X 655/7 Subject: An estimate for repairing the
Principal structures at the seven pagodas.

GOVERNMENT OF MADRAS.

12th April 1881, No. 967 W.

SEVEN PAGODAS.

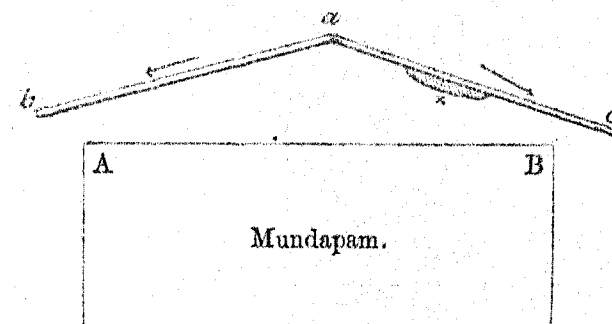
Replacing broken piece of granite off corner (S.W.) of Bhim's Ratha No. 42.

The total contents of the fallen piece is about 81 cubic feet, or 3 cubic yards, at 42* cwt.
* Colonel Foord's Notes, p. 214. per yard = 126 cwt. or 6 tons 6 cwt. This is a heavy weight to be lifted up and hung on to iron bars fastened in the rock of the main structure as the latter is full of cracks.

There is a cornice projecting 8 inches on west face and 5 inches on east face under which a front support could be placed, but the back is sloping very nearly vertically and so could not keep in place without iron bars or some other such arrangement.

It will be best, I think, to clear this piece of the sand about it and leave the block where it is.

The sand-hills to the east should also be planted with "Rabbit wort" to prevent them shifting.

As regards the proposal made in the first item to expend Rs. 690 in lifting and placing in its original position the portion of the rock (weighing over 6 tons) which has fallen out of the west face of the Bhima Ratha, and in supporting the rest of the shaken portion by iron columns as shown by Captain Awdry, the first question that presents itself is whether it is necessary to carry out any restoration here.

It is thus perhaps open to question whether it would on the whole be advisable to do anything just now to this Ratha without further and fuller consideration as to propriety of attempting to restore it to as nearly as possible what may be supposed to have been the intention of the original designers. If, however, it be decided to carry out the work, it may also be open to question whether instead of the proposed iron columns, &c., it would not be more appropriate to introduce a simple block of masonry, without any special form, and merely with the direct object of taking the strain and nothing more. It is thought that such an obvious and unpretentious arrangement would better suit the general character of the Ratha.

4. All the cracks in "Bhima's Ratha" should be carefully "buttoned" with chunam in the usual way; and the buttons dated and watched. So long as there is no actual movement, no danger is to be apprehended.
